V-Knitwear & Composite Ltd. #10248

Mahana, Golakandail, Bhulta, Rupgonj, Narayanganj
(+23.805136N, 90.586609E)

07.MAY.2014

Identified Priority 1 Concerns

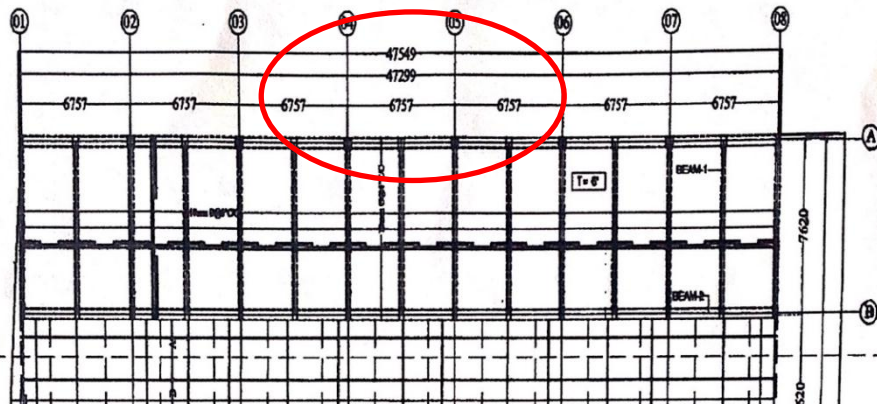
The structural drawings for the main building do not match the existing conditions:

The column grid layout does not match between the flat slab configuration and the slab with beam configuration for the main building.

The beams and columns size don't match the structural drawings for the main building.

An addition across two bays was seen but not shown on the drawings.

- Structural Engineer to review existing conditions and update drawings accordingly.
